TMS320F28075 Piccolo Microcontroller

Silicon Errata

Literature Number: SPRZ423D
October 2014–Revised July 2016

Figure 3. Single-Ended Input Model

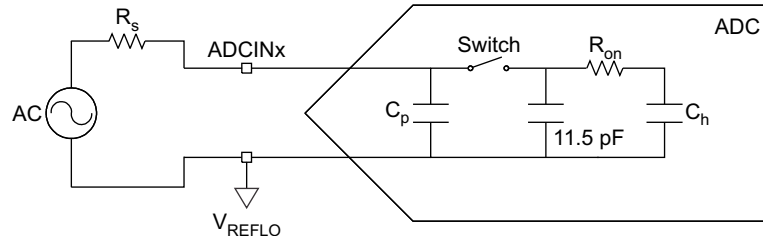
The ADC input model should be used to select the sample-and-hold (S+H) duration for each ADC input. For the revisions affected, if the currently converting channel is an even-numbered channel and the previously converted channel was an odd-numbered channel (or vice versa), then the 12-bit input model will not accurately predict ADC input performance. Under these conditions, an additional capacitance should be added to the model. This capacitance has a value of 11.5 pF and should be placed between the S+H switch and R_{on} as shown in Figure 3.

For the revisions affected, when subsequent conversions switch between channel groups, the S+H duration should be chosen to account for the additional capacitance.
